**FIRST AMENDMENT TO
DECLARATION OF COVENANTS, CONDITIONS AND RESTRICTIONS
FOR HEARTWOOD PRESERVE
OMAHA, DOUGLAS COUNTY, NEBRASKA**

NEW WEST FARM HOLDINGS, LLC, a Nebraska limited liability company, and **SOUTH FARM, LLC**, a Nebraska limited liability company (collectively “Declarant”) hereby execute this **FIRST AMENDMENT TO DECLARATION OF COVENANTS, CONDITIONS AND RESTRICTIONS** (this “First Amendment”) as of the date set forth below.

REPLACEMENT PAGES FOR WEST FARM/SOUTH FARM DESIGN GUIDELINES

LIGHTING

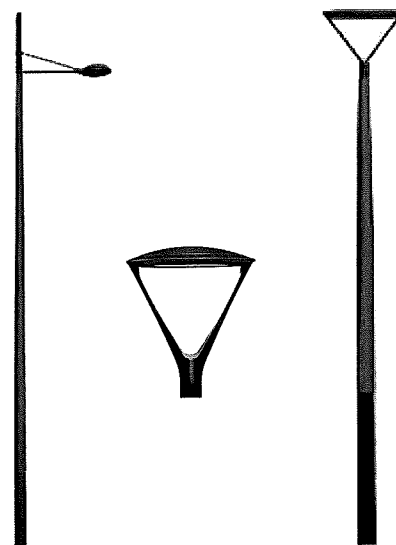
5. Lighting Design Guidelines. Page 60 of the “West Farm/South Farm Design Guidelines,” attached to the Declaration as Exhibit C, is hereby deleted and replaced with a new page and new Appendices thereto, as set forth in Schedule 2, attached hereto.

- » All exterior and parking garage luminaires shall have black finish and utilize LED light sources with a correlated color temperate of 3,000 Kelvin and a minimum color rendering index of 70

- » Pole-mounted lighting shall be from the approved luminaire and pole configurations shown in Appendix 1 or Appendix 2. All other exterior luminaires (including building-mounted, bollards, floodlights and parking garage lighting) shall be submitted to the ACC for approval

- » Design light levels for parking lots and outdoor automotive sales shall comply with the requirements in Appendix 3. Other areas should comply with the standards and recommendations of the Illuminating Engineering Society (i.e. IES RP-8 for Roadway Lighting)

- » Light pollution and trespass shall comply with the Omaha Electrical Code – Chapter 44, Article 5, Division 5. In residential areas light should be directed away from windows

- » Lights shall be automatically controlled based on astronomical time-clock or photocell input. Twist lock photocells may be utilized if they have matching finish to luminaire. Outdoor automotive sales lighting shall automatically dim after 8:00 PM Central to approved parking lot lighting levels
